# Access Compliance Report

## Public Rights-of-Way

### (Curb Ramps)

Intersection ID: 54137	Main Street: KEMP_ST	Cross Street: GLENBROWN_RD	Location: N
ADA ID: 59D84234765A	Ramp Type: Para	Initial Pass/Fail: Fail	Overall Compliance: No
Severity Score: 13.75			
Codes/Mitigation Info/Possible Solution		Field Measurements/Component Compliance

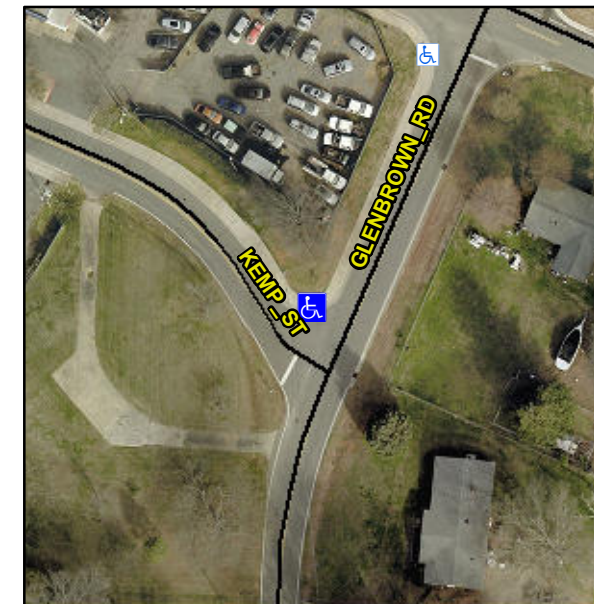
**R304.3.2, R304.5.3**

Compliance	Description	Data	Compliance	Description	Data
N/A	Ramp Length LT (in)	43.0	N/A	Ramp Length RT (in)	43.0
Yes	Ramp Width LT (in)	68.0	Yes	Ramp Width RT (in)	67.0
No	Ramp Slope LT (%)	10.2	Yes	Ramp Slope RT (%)	6.2
No	Ramp XSlope LT (%)	2.5	Yes	Ramp XSlope RT (%)	0.9
N/A	Landing Length (in)	N/A	N/A	DWS Provided?	N/A
N/A	Landing Width (in)	N/A	N/A	DWS Contrast?	N/A
N/A	Landing Slope (%)	N/A	N/A	DWS Length (in)	N/A
N/A	Landing X Slope (%)	N/A	N/A	DWS Full Width?	N/A
N/A	Landing Curb? (Y/N)	N/A	N/A	DWS Offset (in)	N/A
N/A	Shared Landing?	N/A			
N/A	Gutter Ponding?	N/A	N/A	Gutter Slope (%)	N/A
N/A	Gutter Lip Ht (in)	0.5	N/A	Gutter X Slope (%)	N/A
N/A	Painted X Walk1?	No	N/A	Painted X Walk2?	N/A
	X Walk 1 Direction	To S		X Walk 2 Direction	N/A
N/A	X Walk 1 Width (in)	N/A	N/A	X Walk 2 Width (in)	N/A
	X Walk 1 Slope (%)	2.6		X Walk 2 Slope (%)	N/A
	X Walk 1 X Slope (%)	2.2		X Walk 2 X Slope (%)	N/A
N/A	Ramp inside XWalk1?	N/A	N/A	Ramp inside XWalk2?	N/A

**Remove & Replace Entire Ramp.**
